Access Compliance Report

Public Rights-of-Way (Curb Ramps)

Intersection ID: 49359	Main Street: PARK_SOUTH_DR	Cross Street: GARDEN_PATH_LN	Location: E
ADA ID: 859A6056CF8B	Ramp Type: PerpDiag	Initial Pass/Fail: Fail	Overall Compliance: No
		Severity Score: 25

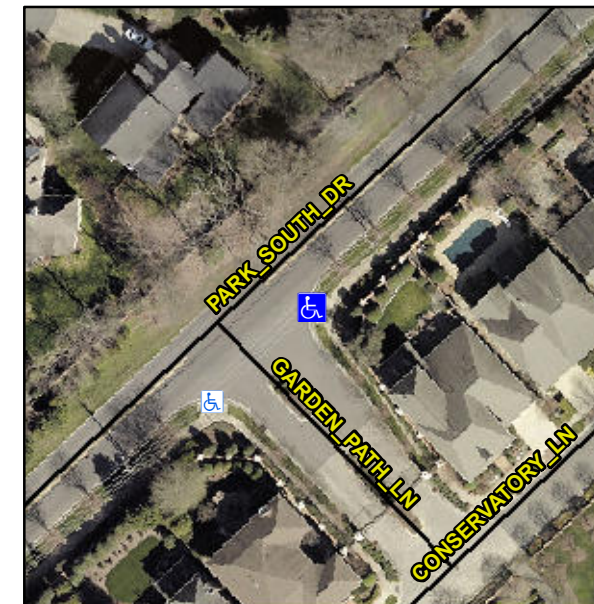
Not Found, R304.5.3

Compliance	Description	Data	Compliance	Description	Data
N/A	Ramp Length (in)	132.0	Yes	Ramp Slope (%)	7.1
Yes	Ramp Width (in)	48.0	No	Ramp XSlope (%)	11.2
N/A	Flare Type LT	N/A	N/A	Flare Type RT	N/A
N/A	Flare Slope LT (%)	N/A	N/A	Flare Slope RT (%)	N/A
N/A	Flare Traversable LT?	N/A	N/A	Flare Traversable RT?	N/A
N/A	Landing Length (in)	N/A	N/A	DWS Provided?	N/A
N/A	Landing Width (in)	N/A	N/A	DWS Contrast?	N/A
N/A	Landing Slope (%)	N/A	N/A	DWS Length (in)	N/A
N/A	Landing X Slope (%)	N/A	N/A	DWS Full Width?	N/A
N/A	Landing Curb? (Y/N)	N/A	N/A	DWS Offset (in)	N/A
N/A	Shared Landing?	N/A			
N/A	Gutter Ponding?	N/A	N/A	Gutter Slope (%)	N/A
N/A	Gutter Lip Ht (in)	N/A	N/A	Gutter X Slope (%)	N/A
N/A	Painted X Walk1?	No	N/A	Painted X Walk2?	No
	X Walk 1 Direction	To N		X Walk 2 Direction	To SW
N/A	X Walk 1 Width (in)	N/A	N/A	X Walk 2 Width (in)	N/A
	X Walk 1 Slope (%)	8.5		X Walk 2 Slope (%)	1.7
	X Walk 1 X Slope (%)	4.3		X Walk 2 X Slope (%)	8.7

Remove & Replace Curb Ramp With Two New Directional Ramps or Equivalent.
